Product Change Notification

PCN24-18- KMT0 Series Teflon Film Change

Visual change:

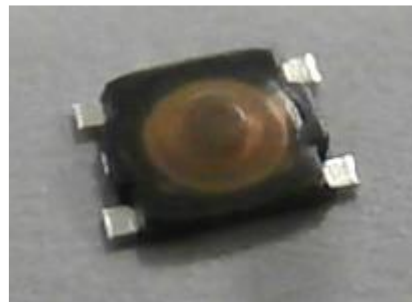
This PCN is to inform of the change of Teflon film used in the KMT0 Tactile Switch series due to the obsolescence notified by the supplier.

Impact of Change: No decrease of the product performance and no change of the specification.
The qualification report can be shared on request. Samples will be available from 16th September 2024.
